SR-2 – STAFF ADVISORY REPORT (06-05-2026)

ADDRESS: 4038 FULLERTON

APPLICATION NUMBER: HDC2026-00225

SCOPE: REPLACE VINYL WINDOW WITH VINYL WINDOW

Designation photo, 1999. HDAB

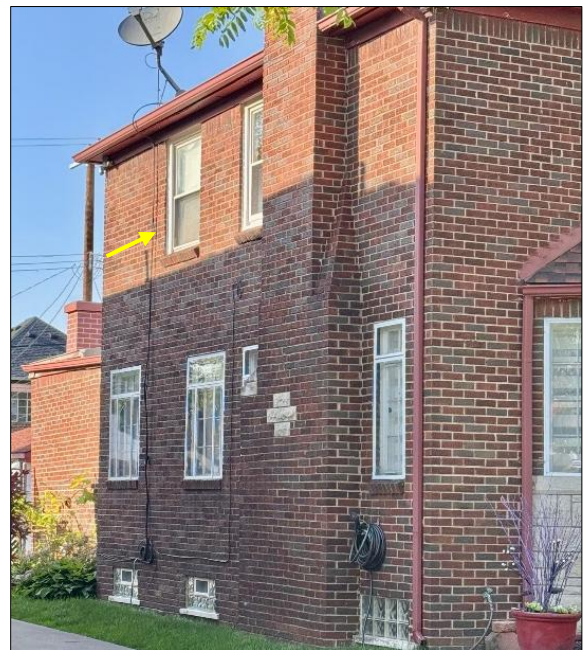
- The building permit for the dwelling was issued on 06/05/1939.
- Per the designation photo, the house's original windows at the second floor were no longer extant at the time of district designation. Steel casement windows remain in many of the first floor window openings on the front and side walls.
- In 2000, HDC staff approved the installation of six (6) vinyl windows.
